2024.00373.000

George Hotel
Refurbishment (Planning & LBC)
Response – Cycle Storage

(File Ref: 2025_4891147_W - 15 - Response - Cycle Storage_29.08.25)

August 2025

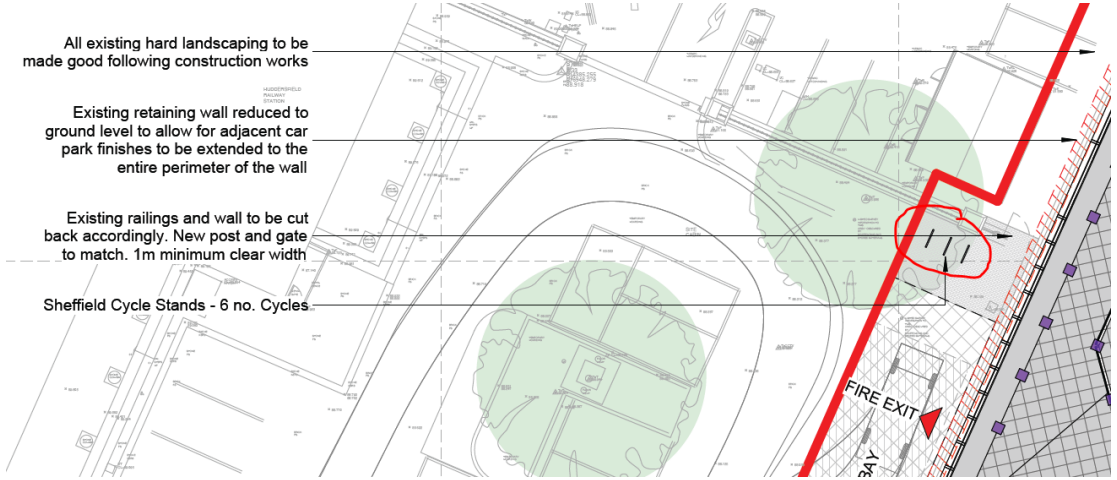
The applicant, agent and lead architect have been attending fortnightly meetings with the LPO and conservation officers and in meeting on 26July 2025 this matter was raised over concerns that the current application did not appear to allow for the provision of cycle storage.

On 02.07.25 AHR submitted additional information namely the site plan below which indicated the provision of 3nr Sheffield stand hoops to the side entrance/ railway station elevation (for 6nr cycles):

The applicant supplied this information with an explanation that the provision of cycle storage internally is extremely problematic from a fire compliance perspective due to recent concerns around electric cycles and lithium battery fires which could not reasonably be mitigated.

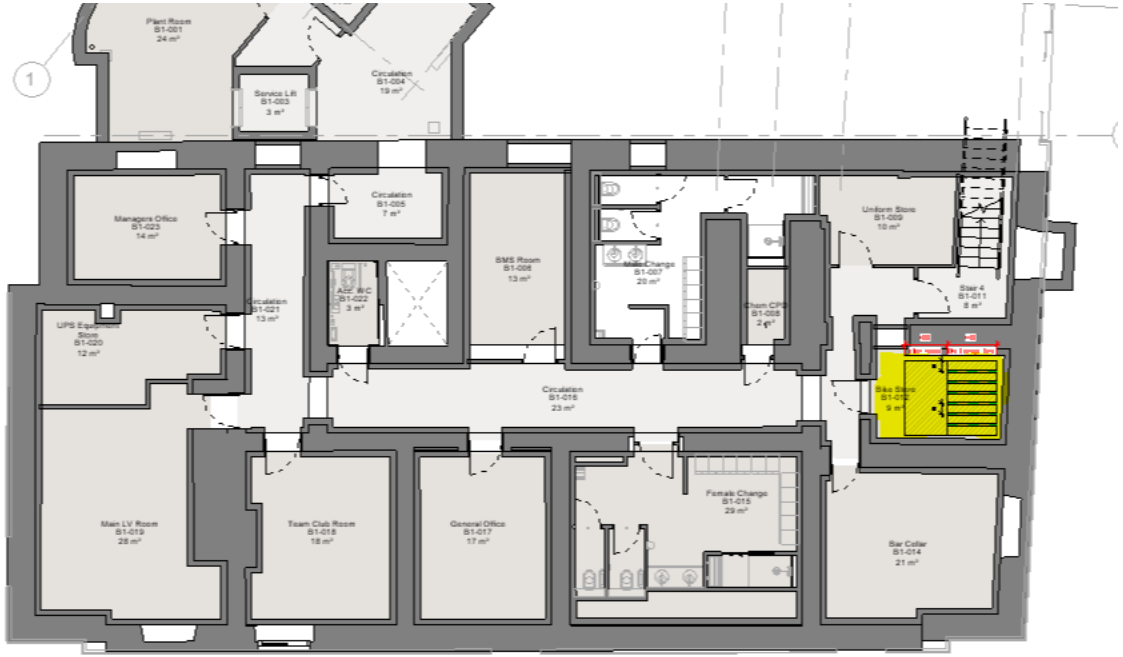
Further discussion between the applicant and the LPO have reached a reasonable compromise to provide 6nr non-ebike storage within the basement of Block A and 3nr external hoops for e-bikes which will be covered by CCTV as below highlighted in Yellow (noting this is served by the large capacity lift within the new block B):

Internal 6nr (non-ebike)
The applicant undertakes in this application to provide 6nr internal cycle store stands in a stand alone & secure location within the building which can easily accessed via the side entrance via the main high-capacity lift.

External 6nr (ebike)
The applicant undertakes in this application to provide 3nr stainless steel Hoops to the side entrance of the hotel which is to be overlooked by CCTV for the purpose of providing external cycle parking/ lock location under a monitored location for 6nr cycles (2/ hoop). It is noted this also provides for occasional visitation scenarios also and as such should be considered an enhancement to the previously required numbers.
